STATE OF NEW MEXICO  
DEPARTMENT OF ENERGY, MINERALS AND NATURAL RESOURCES  
OIL CONSERVATION COMMISSION

IN THE MATTER OF  
APPLICATION OF APACHE CORPORATION  
FOR AN ADJUDICATORY HEARING TO  
CONTEST THE DIVISION'S CONDITIONS OF  
APPROVAL ON APACHE CORPORATION'S  
SCOPE OF WORK FOR ADDITIONAL  
INVESTIGATION, LEA COUNTY, NEW MEXICO

OCC CASE NO. 24912  
ORDER NO. R-23728-A

ORDER GRANTING APACHE CORPORATION AND THE OIL CONSERVATION DIVISION'S  
JOINT MOTION TO AMEND ORDER NO. R-23728

Exhibit B

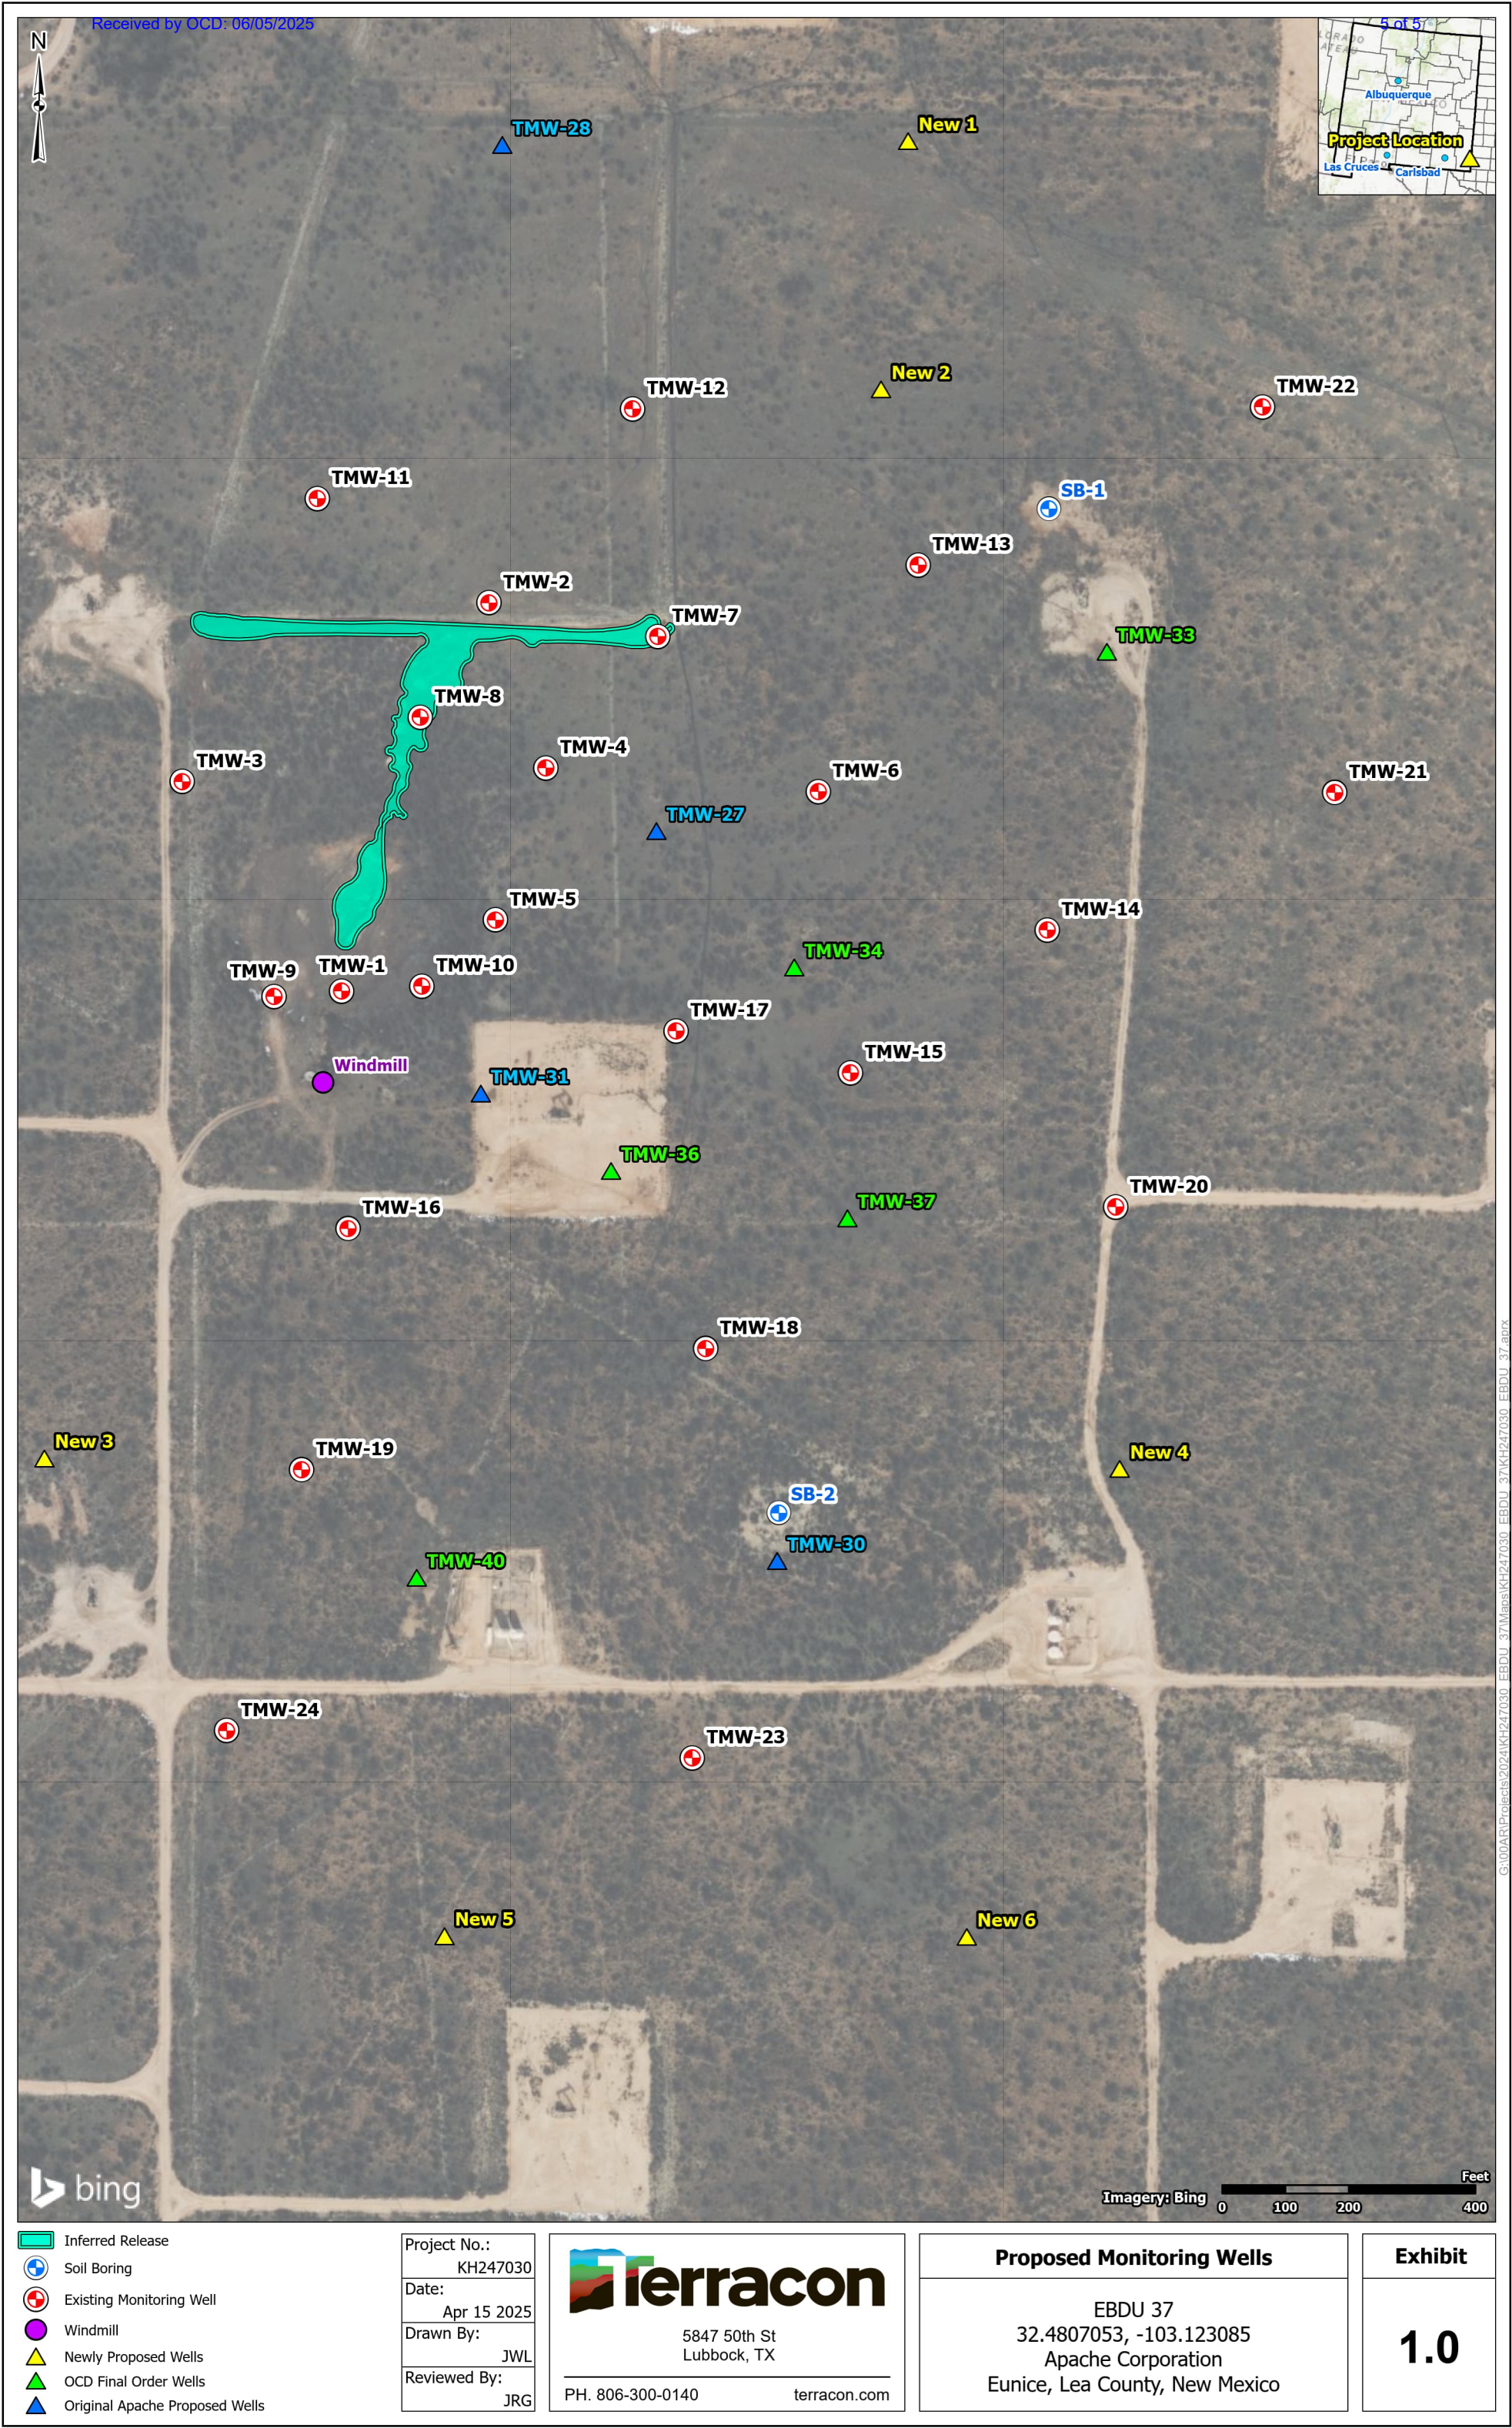
1. As part of Permit API 30-025-06556, Apache Corporation must commence the following within ninety (90) days of the date of the Oil Conservation Commission's Order granting the Joint Motion to Amend Order No R-23728. The coordinates for each monitoring well are included below. Groundwater Monitoring Wells:

- a. TMW-27 (32.479989°, -103.120675°) will serve to confirm the chloride plume is continuous between the source (near TMW-7) and TMW-17, which has shown elevated chlorides in recent sampling.

- b. TMW-28 (32.482492°, -103.121341°) will provide upgradient delineation. This well will be located approximately 750 feet upgradient of the source.

- c. TMW-30 (32.477327°, -103.120154°) will be located approximately 200 feet southeast of TMW-18 to provide information on stratigraphy and groundwater chemistry in the space between current TMW-18, TMW-23, and proposed New 4. This is the location identified as TMW-39 from the original OCD Conditions of Approval.

- d. TMW-31 (32.479032°, -103.121434°) will be installed approximately 200 feet east of the Windmill. This well is also requested in condition 5 of the OCD final order.

- e. TMW-33 (32.480650, - 103.118951) will be installed approximately 415 feet southwest of TMW-22. Reduces the distance between TMW-21 and TMW-13 for more precise characterization.

- f. TMW-34 (32.479492, - 103.120080) will be installed approximately 350 feet west of TMW-14. Achieves more characterization near TMW-17.
  - g. TMW-36 (32.478749, -103.120871) will be installed approximately 175 feet southwest of TMW-17. Addresses need for more characterization near TMW-17

- h. TMW-37 (32.478577, -103.119850) will be installed approximately 275 feet southeast of TMW-17. Provides additional characterization near TMW-17.
  - i. TMW-40 (32.477265°, -103.121711°) will be installed approximately 200 feet southeast of TMW-19. Addresses lack of characterization and assessment between TMW-19 and TMW-18

- j. New 1 (32.482505°, -103.119588°) This is a modification (approximately 100 feet east) of the OCD final order well TMW-30. Better defines background concentrations.

- k. New 2 (32.481600°, -103.119705°) This is a modification (approximately 100 feet northeast) of the OCD final order well TMW-32. Reduces distance between adjacent wells for more precise characterization.

- l. New 3 (32.477701°, -103.123321°) This is a modification (approximately 150 feet west) of the well requested in Condition 6 of the OCD final order well. Provides delineation west of TMW-19.

- m. New 4 (32.477662°, -103.118673°) This is a modification (approximately 250 feet east) of the OCD final order well TMW-38. Better defines background concentrations. Provides characterization in the southeast of the site.

- n. New 5 (32.475958°, -103.121591°) This is a modification (approximately 200 feet south) of the OCD final order well TMW-41. Provides downgradient characterization at the southern extent of the release area.

- o. New 6 (32.475825°, -103.119373°) This is a modification (approximately 200 feet southeast) of the OCD final order well TMW-42 (condition 11). Provides downgradient characterization at the southeastern extent of the release area.

2. Soil borings:
- a. SB-1 (32.481164°, -103.118979°) This boring is proposed in a location approximately 180 feet northeast of existing monitoring well TMW-13. The boring is located centered on an area with restricted vegetation growth suspected of being a potential source of contaminants leaching to groundwater.

- b. SB-2 (32.477502°, -103.120147°) This boring is proposed approximately 230 feet southeast of existing TMW-18. The boring is located centered on an area with restricted vegetation growth suspected of being a potential source of contaminants leaching to groundwater.
